**William J. Devine Golf Course
Cart Boardwalk at Scarborough Pond
WSE Project No. 2160342.E**

April 4, 2018

Re: *NOI Filing*
William J. Devine Golf Course Cart Boardwalk at Scarborough Pond
1 Circuit Drive

EXISTING CONDITIONS PLAN

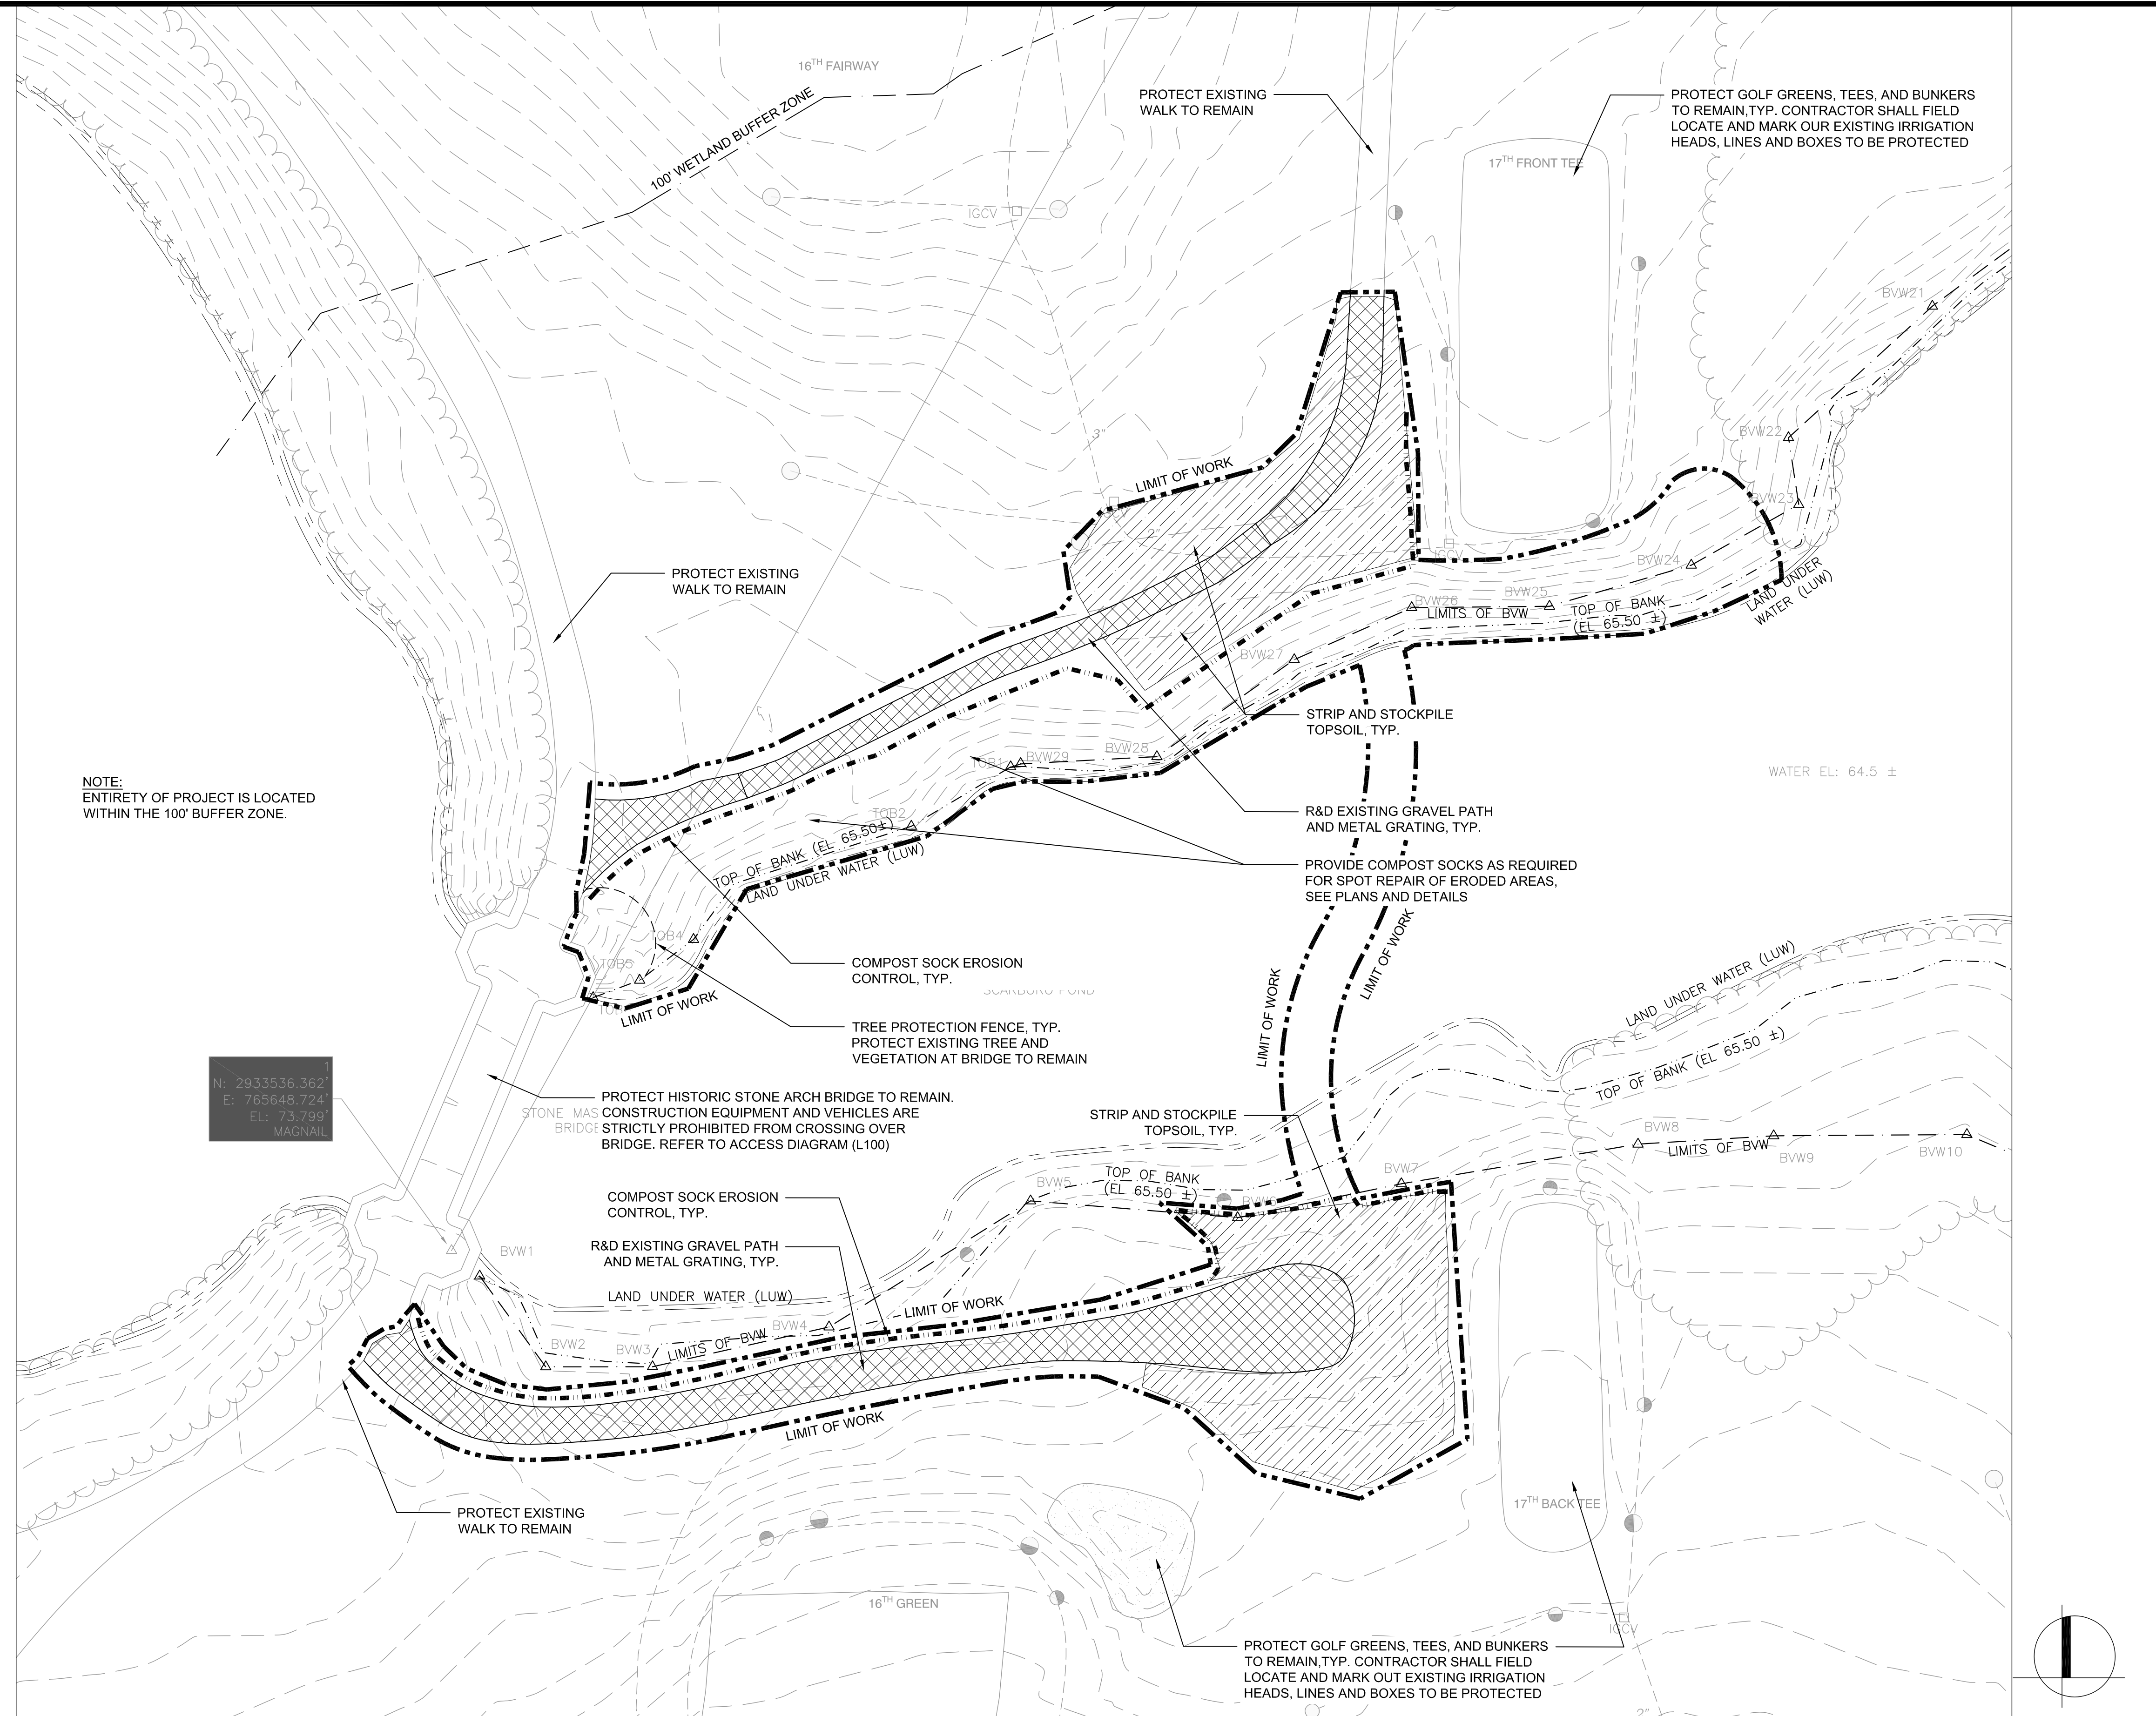
The plans have been revised to more accurately delineate the resource areas at the project location. The 'Top of Bank' delineation line has been extended on both sides of the pond, and matches the approximate Top of Bank elevation (65.50) previously delineated on the plans. Environmental impact numbers have been revised based on the new Top of Bank delineation.

The 100-Year FEMA Flood line delineation has been removed from the plans. After more research, Weston & Sampson believes this line had been erroneously included and misidentified in the survey of the existing conditions. Per the FEMA NFHL Firmette map previously provided, there is no Land Subject to Flooding or 100-Year Flood Elevation indicated at Scarborough Pond. Environmental impact numbers have been revised based on the removal of the erroneous 100-Year FEMA Flood line.

SITE PREPARATION PLAN

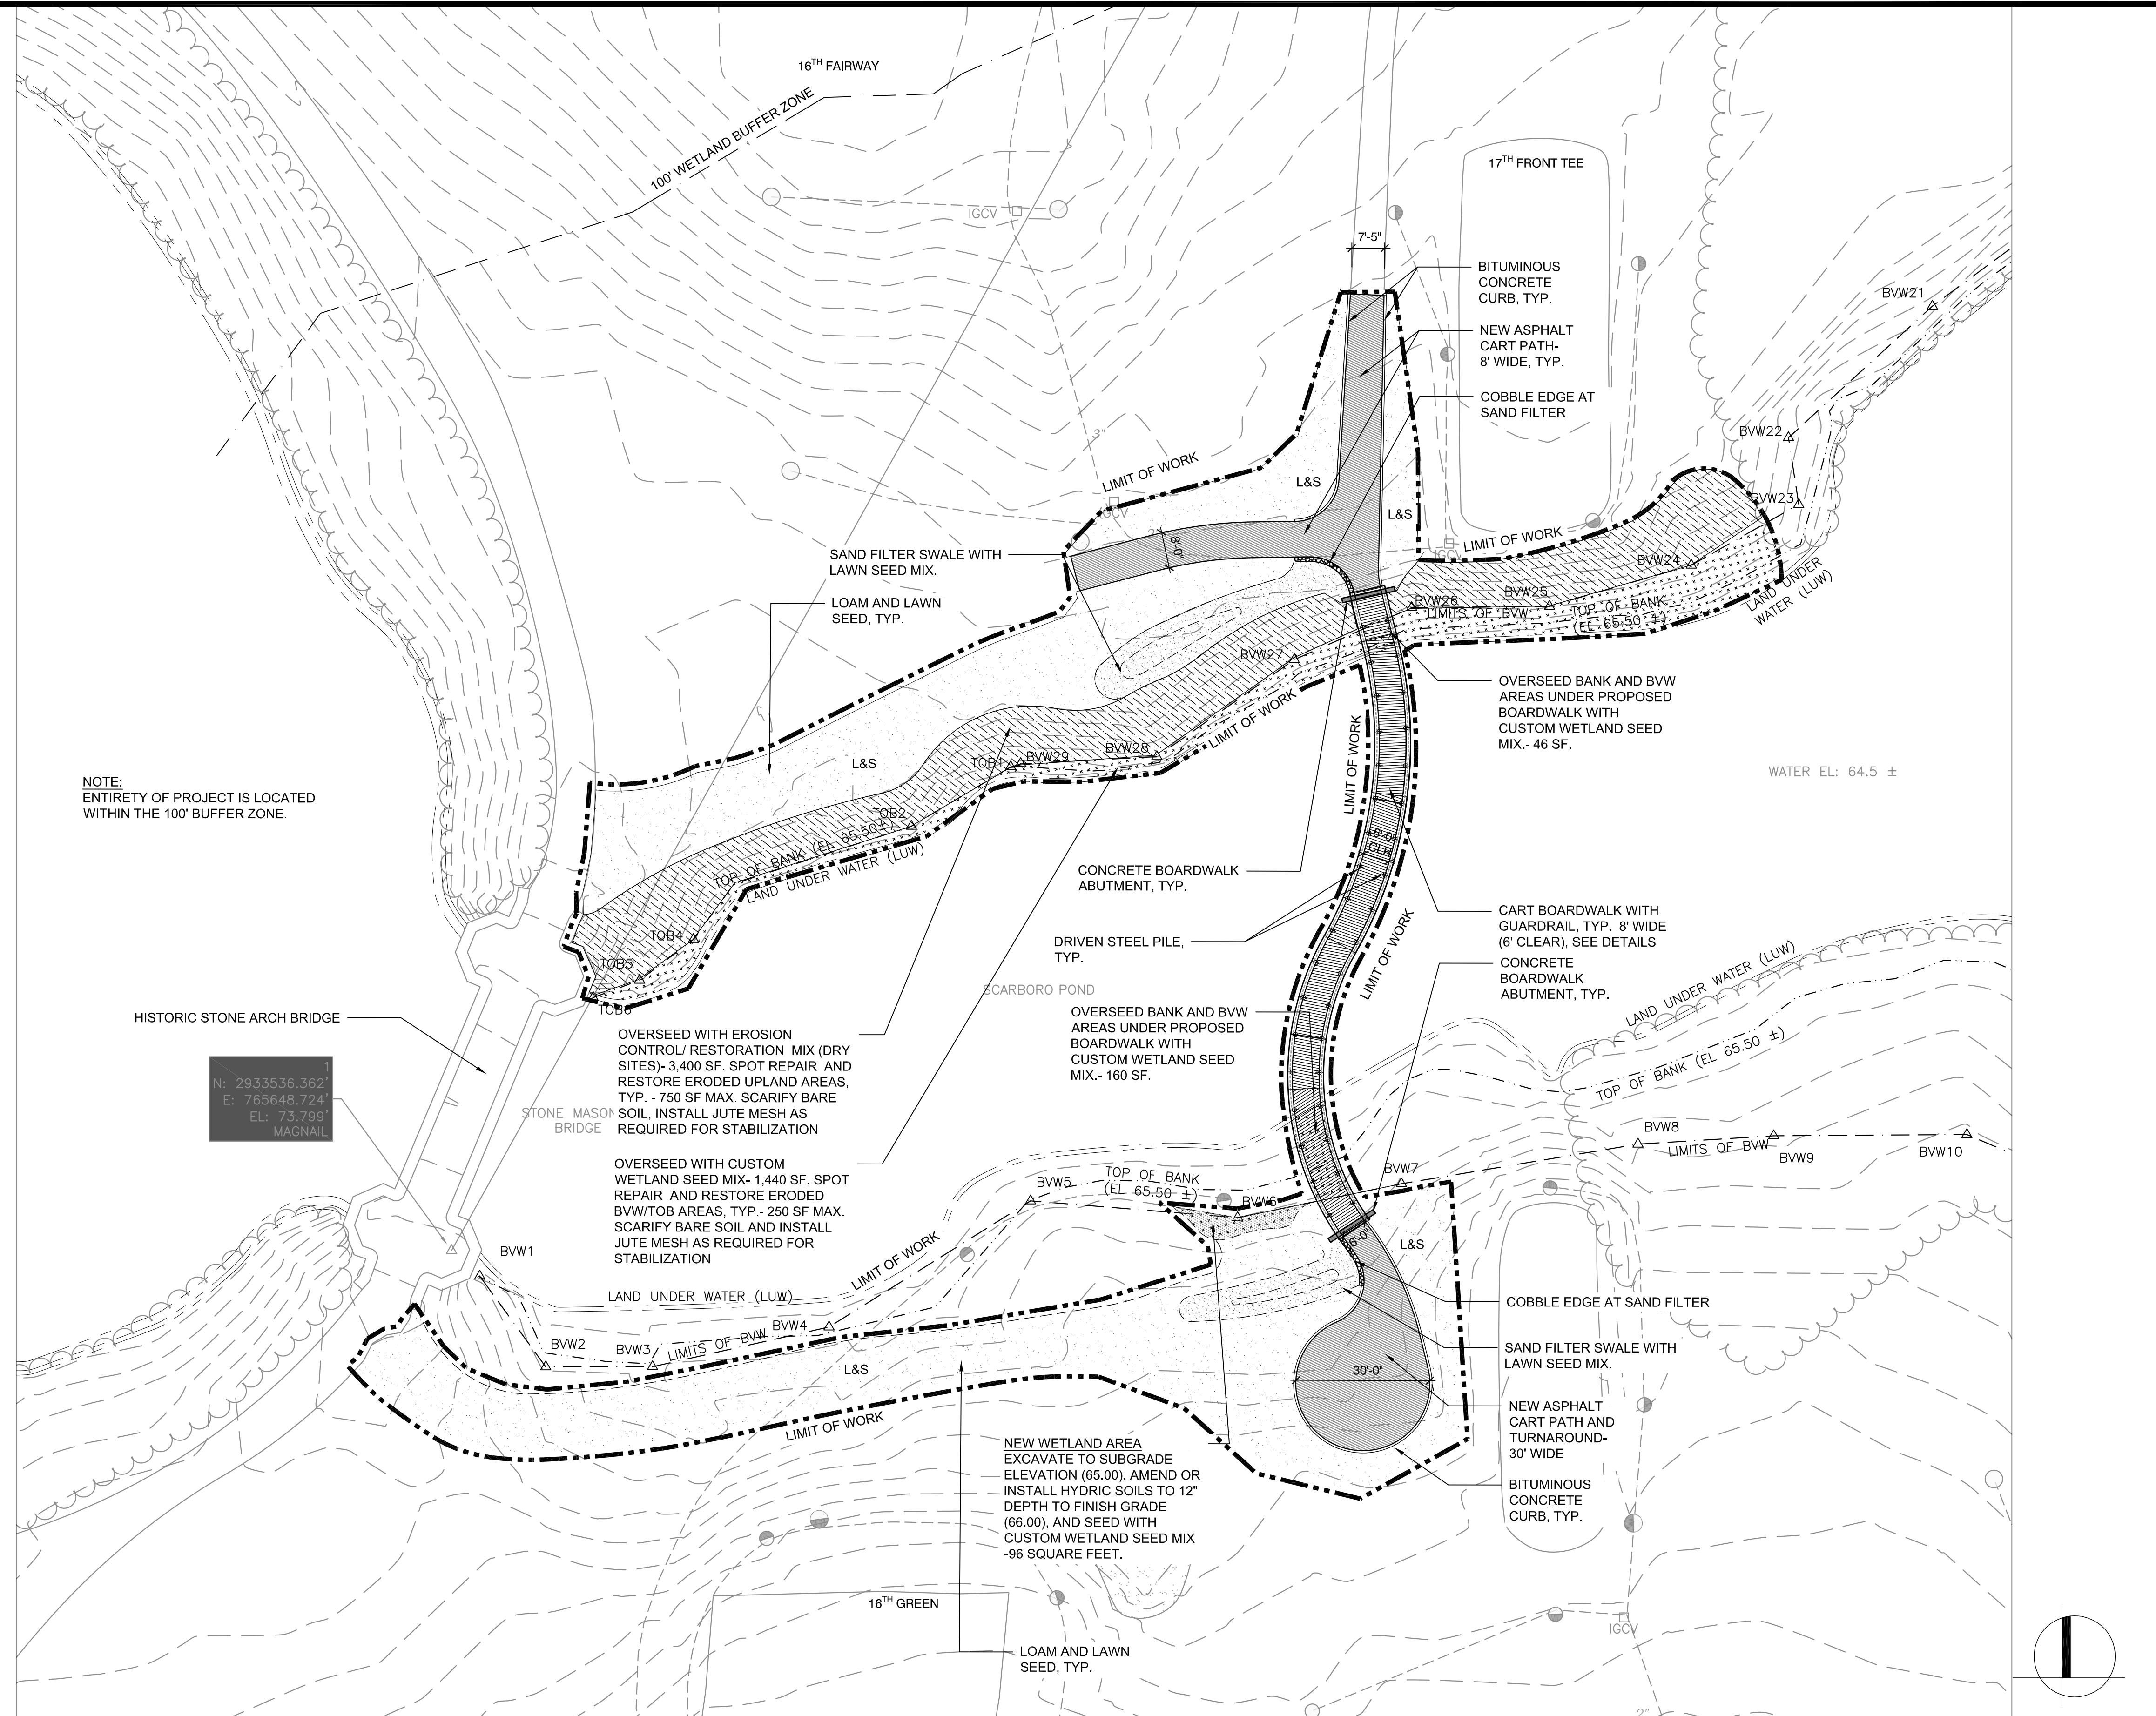
The plans have also been revised to include 96 SF of new wetland area, to mitigate for possible environmental impacts (as previously described in the Environmental Impacts section of this memo). The wetland work will occur adjacent to the southern end of the proposed boardwalk, and all relevant plans have been revised to delineate this work.

The project will require overseeding of custom wetland seed mix at BVW/TOB areas below the proposed boardwalk. This is intended to help mitigate potential shade impacts by introducing additional wetland and shade tolerant vegetation. In addition to spot repair of eroded areas (as previously submitted), the project will also require overseeding of upland areas with an erosion control seed mix, and overseeding of BVW/TOB areas with custom wetland seedmix on the northern slope of the pond. This work has been more clearly articulated on the plans.
